APPENDIX 4

4A ANSWERS TO QUESTIONS

QUESTION THERMAL SHOCK ON REACTOR VESSEL

SACRAMENTO MUNICIPAL UTILITY DISTRICT

FIGURE 4A.1-4  
TEMPERATURE PROFILES DUE  
TO ECCS OPERATION

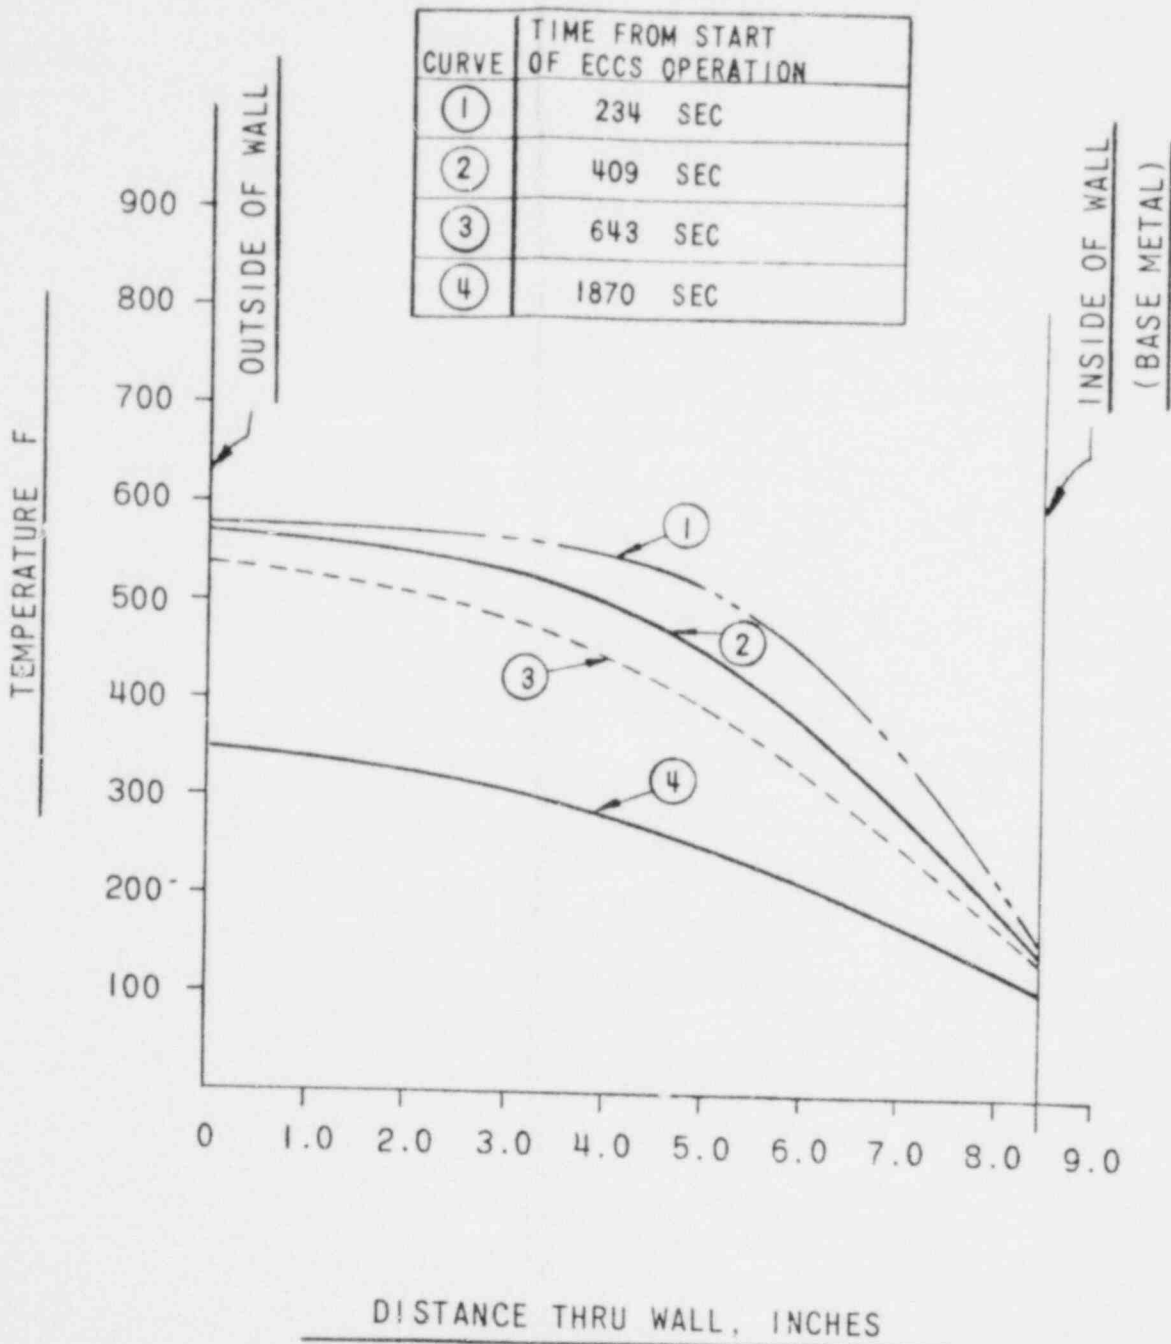
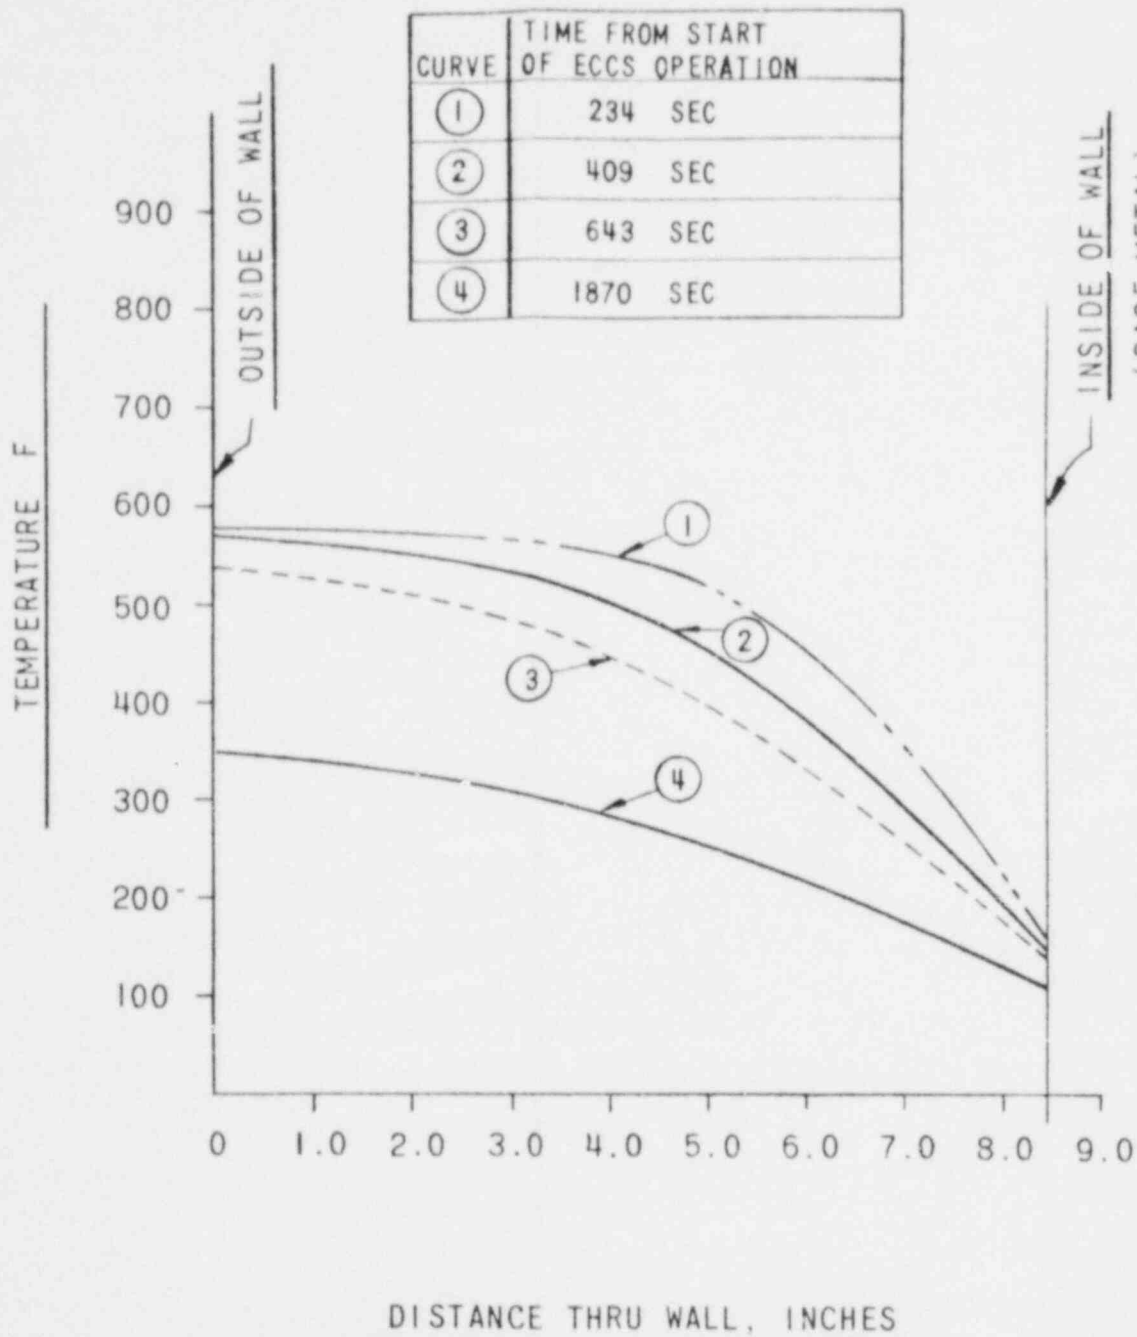
4A.1 With regard to thermal shock on the primary system components, induced by operation of the emergency core cooling system (ECCS), provide details of an analysis which indicates that the reactor vessel can accommodate without failure the rapid temperature change at the end of its design life. The analysis should consider both the ductile yielding and the brittle fracture modes of failure, and should include the following specific information: (See these further specific items following the answer to Question 4A.1.)

assumed. The crack arrest temperature through the thickness of the wall was developed on a stress-temperature coordinate system. The actual quench-induced, stress-temperature condition through the thickness of the wall at several times during the quench was developed and plotted (Figures 4A.1-4 and 4A.1-5). The maximum depth at which the material in the vessel wall would be in tension or at which the stress in the material would be in excess of the threshold stress for crack initiation (5-8 ksi) was determined by comparison of the plots. Comparison shows that a crack could propagate only through the inner 35 percent of the wall thickness if a crack initiation threshold of 5-8 ksi is applicable, and further that a crack could propagate only through the inner 43 percent of the wall thickness if a crack initiation threshold of zero were assumed.
